Conway Planning Commission
Staff Report

7:00pm • May 21, 2018 • 810 Parkway Avenue

C1 CHERRY HILL PHASE 2 PRELIMINARY SUBDIVISION

CONWAY CITY PLANNING DEPARTMENT REVIEW CHERRY HILL PHASE 2 PRELIMINARY PLAT

Proposed Preliminary Plat

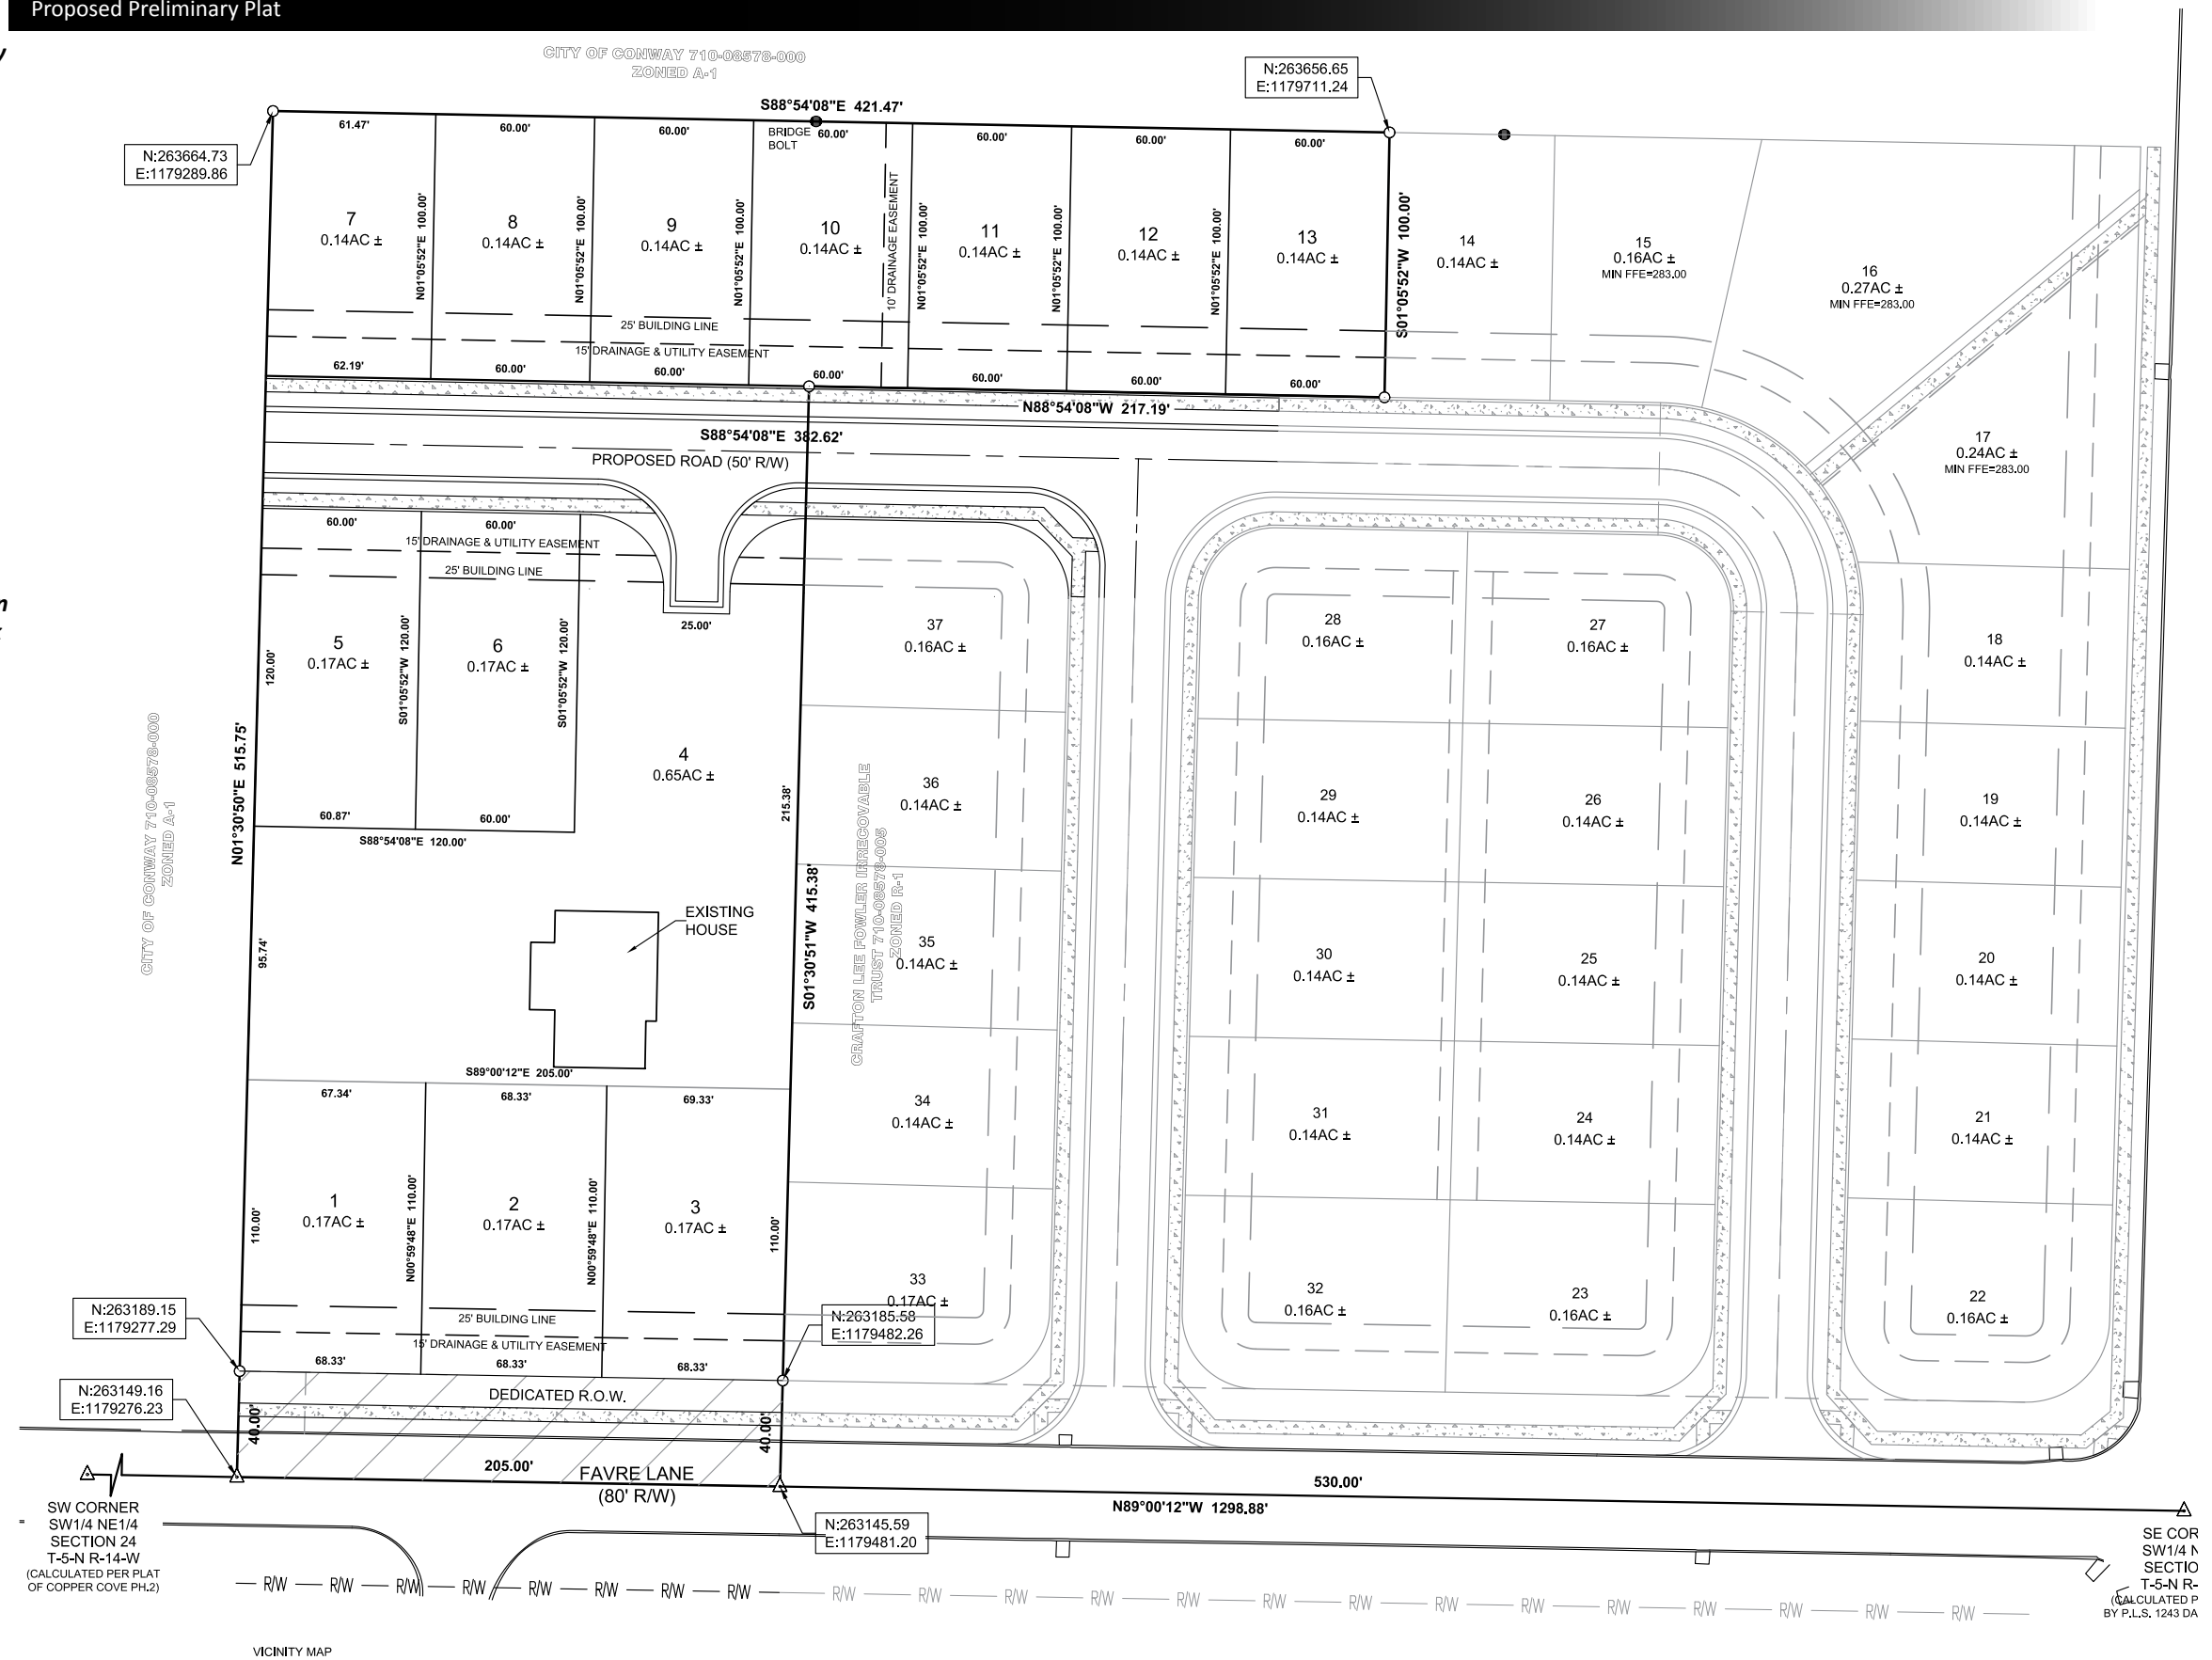
requirement must be approved by the Conway Fire Marshall. **The proposed turnaround exceeds 150' from the end of the dead end street and is not a cul-de-sac which requires Conway Fire Marshall approval. Planning Commission Approves / Does not Approve this condition, or this condition must be corrected.**

21. All existing buildings must be shown to meet the minimum setback requirements from all lot lines or they must be modified or moved to meet those setback requirements. **Existing house on Lot 4 now faces Proposed Road, so southern lot boundary becomes the rear setback. 25' min. rear setback required in R1 zone. Planning Commission Approves / Does not Approve this request, or this condition must be corrected.**

Applicant provided sketch with proposed Planning Staff modifications in red

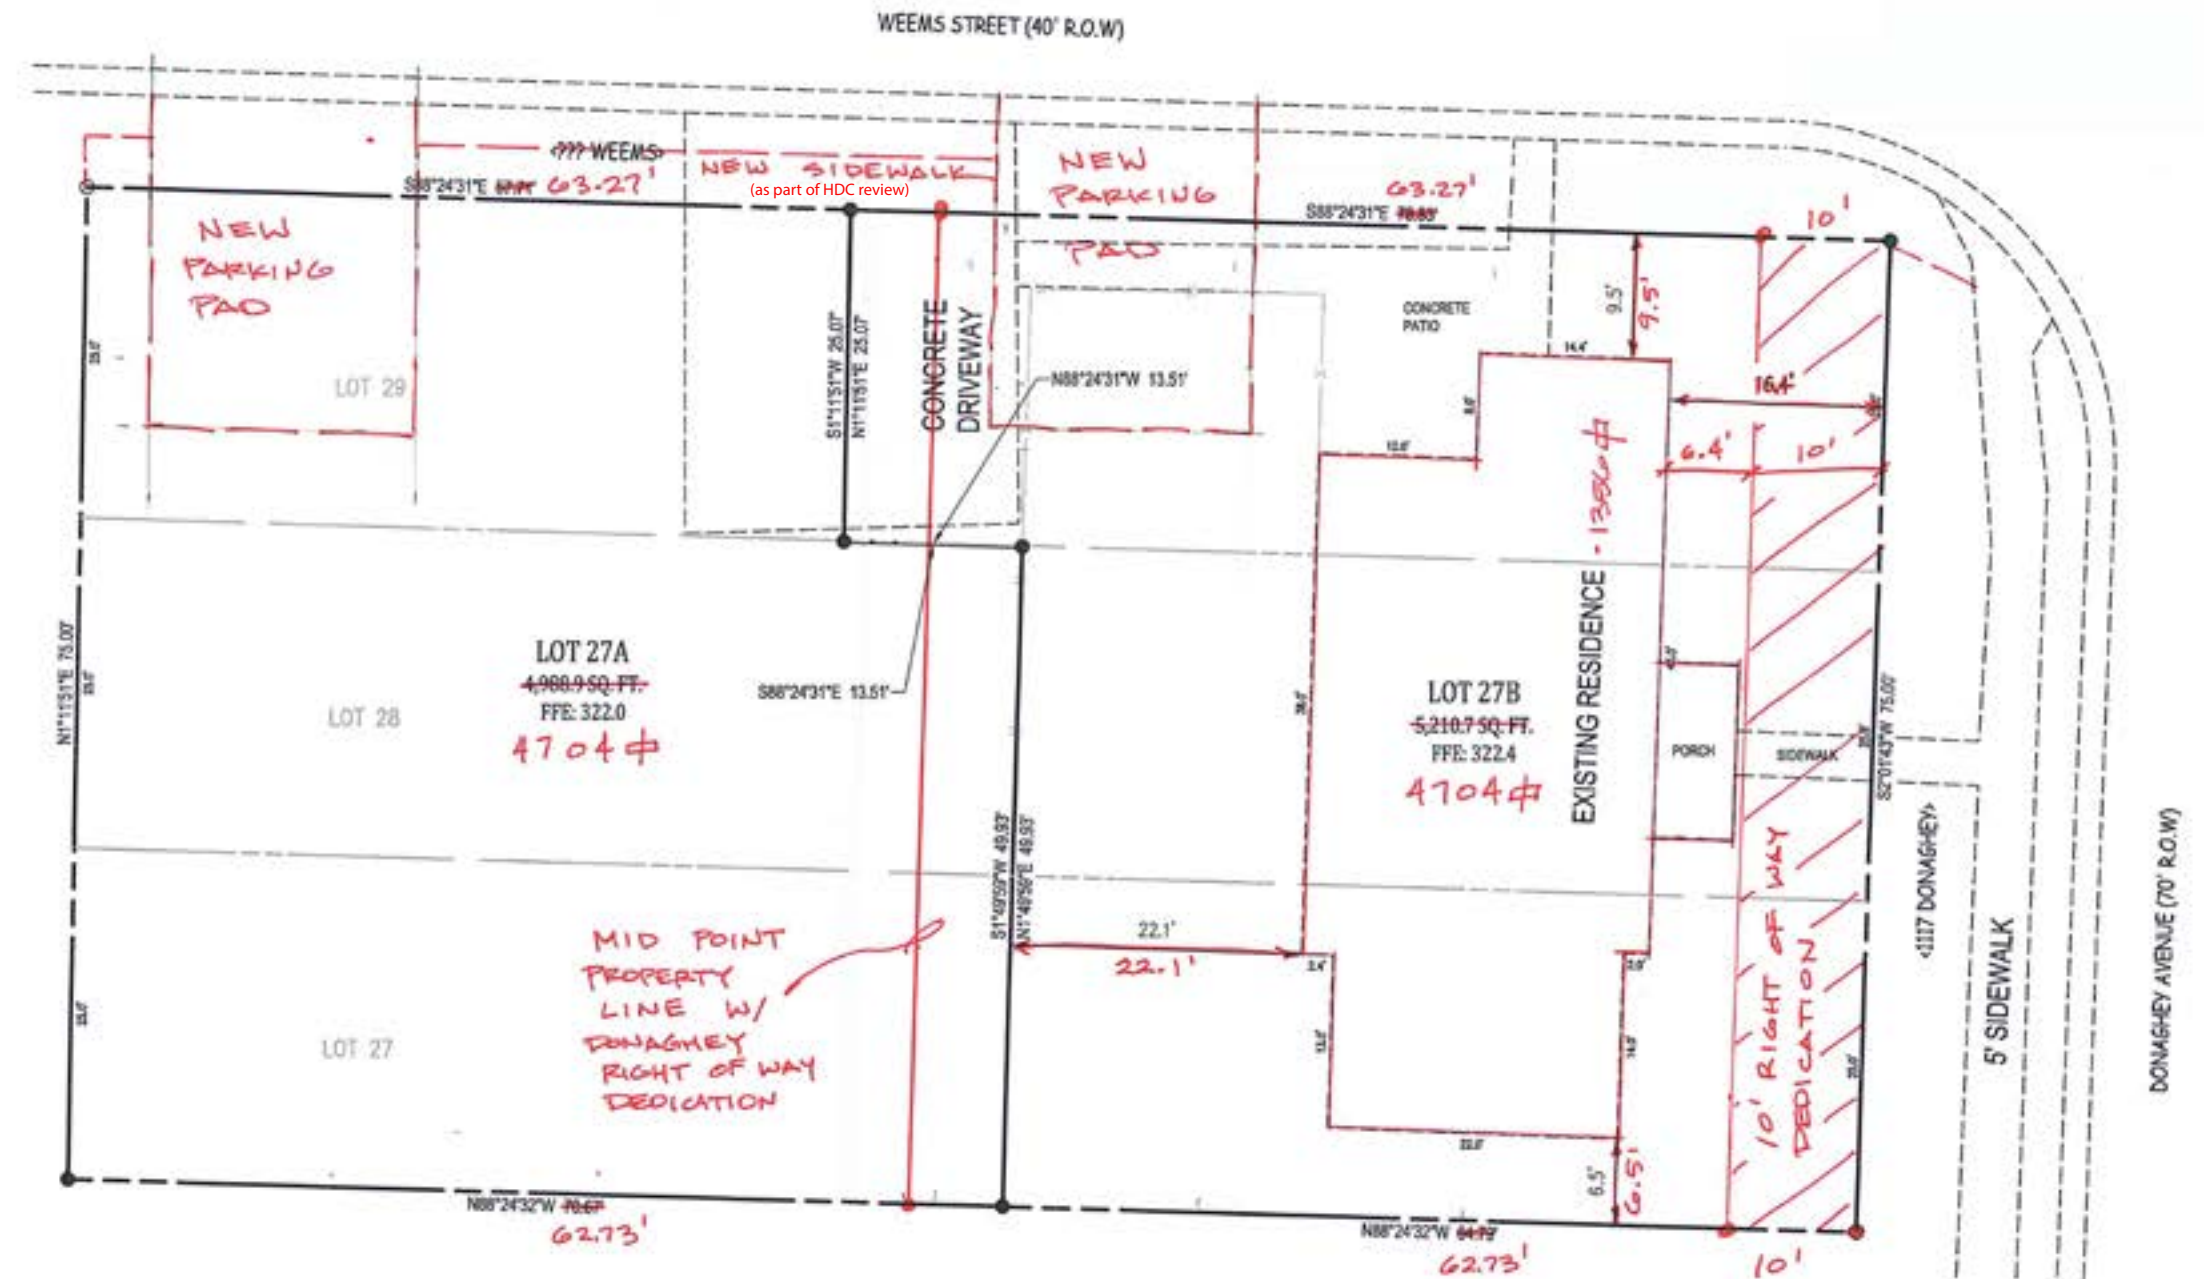
Planning Staff recommends that the dividing property line be placed at the mid point creating two approximately equal sized lots after Donaghey right of way dedication. The submitted plat shows a property line jogging around and through an existing parking pad. Planning Staff recommends that mid point property line be set without regard to the parking pad. The existing parking pad should be demolished in order to create appropriate parking for both lots. The existing pad is likely too small to be divided in two. A property line down the center could also create potential parking disputes. Expansion of the parking pad would create a large area of concrete that would not blend well with the area. A new parking pad should be created for the existing residence and a separate parking pad or driveway can be created on the west side of the newly created lot.

1. The plat will be divided as shown on Planning Staff sketch removing the proposed jogged property line around the existing concrete parking pad.
2. The existing concrete parking pad shall be demolished and a new more appropriately located parking pad shall be created to serve the existing residence. The Historic District Commission shall determine the most appropriate location for a new driveway/parking pad on the newly created lot.
3. A sidewalk shall be constructed along the Weems Street frontage of the west lot as part of the new construction in the Old Conway Design Overlay District or an in-lieu fee may be paid if placement of the sidewalk is not appropriate due to trees, existing sidewalks, utilities, etc. This sidewalk construction or in-lieu fee must take place prior to issuance of a certificate of occupancy for the new residence.
